# City of Detroit

**CITY PLANNING COMMISSION**  
208 Coleman A. Young Municipal Center  
Detroit, Michigan 48226  
Phone: (313) 224-6225 Fax: (313) 224-4336  
e-mail: [cpc@detroitmi.gov](mailto:cpc@detroitmi.gov)

**RE:** **Request of Innovo to modify the existing Planned Development zoning classification established by Ordinance No. 6-90 on Zoning Map No. 67 generally located between the Southfield Freeway and Artesian St. north of the I-96 Expressway to allow for the modification of an existing greenbelt (RECOMMEND APPROVAL WITH CONDITIONS)**

**DATE:** January 29, 2024

**FENCESCREEN PRIVACY PLUS 90% BLOCKAGE**

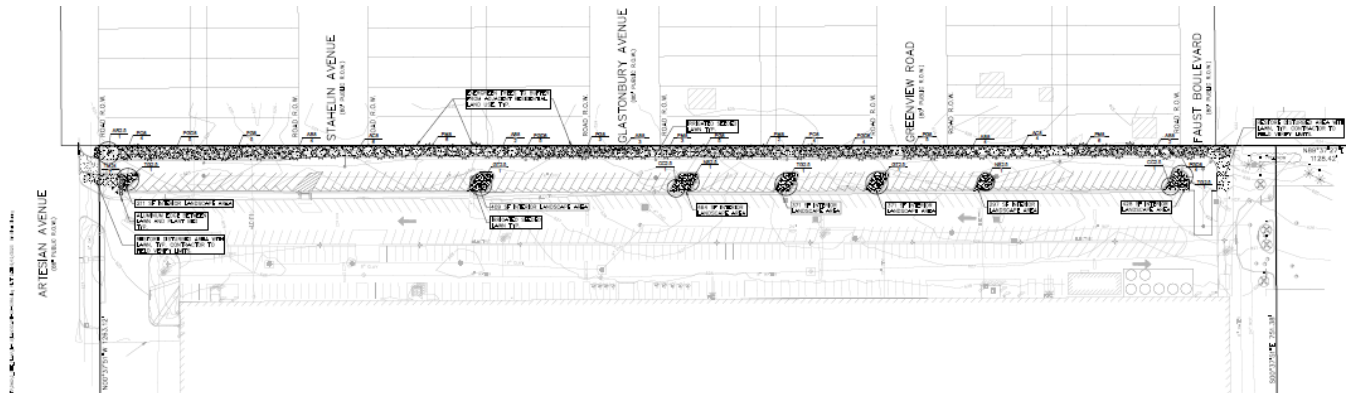
- Innovo proposes to affix green mesh screening (shown below) along the fence line to both obscure the view of the facility from the adjacent residential community until the trees

CPC staff would have preferred the fencing to be shorter; unfortunately, BSEED issued a permit allowing the 12-foot-high fence. As a result, CPC staff supports keeping the new fence and supports the petitioner’s request to add the green privacy screen with 90% blockage. The green privacy screen will screen the industrial buildings and parking to the south, especially until the proposed landscaping can grow and fill in. If over time, the proposed landscaping is able to provide adequate buffering, CPC staff recommends the property owner petition the CPC to remove the green privacy screen.

1. To allow the existing 12-foot-high chain link fence with barbed wire to remain and to require the addition of a green privacy screen with 90% blockage be installed and maintained. Once the proposed landscaping is able to provide adequate buffering, the property owner may petition the CPC to remove the green privacy screen;
2. That the landscaping plan be revised to show proposed evergreen spacing 10 to 15 ft apart dependent on species, 5 ft apart for arborvitae, and additional plantings be added where feasible, with the final landscaping plan, including the final selection of species, be subject to the review and approval by CPC staff; and
3. That the final site plans, elevations, lighting, landscaping, and signage plans be submitted by the developer to the staff of the CPC for review and approval prior to making application for applicable permits.
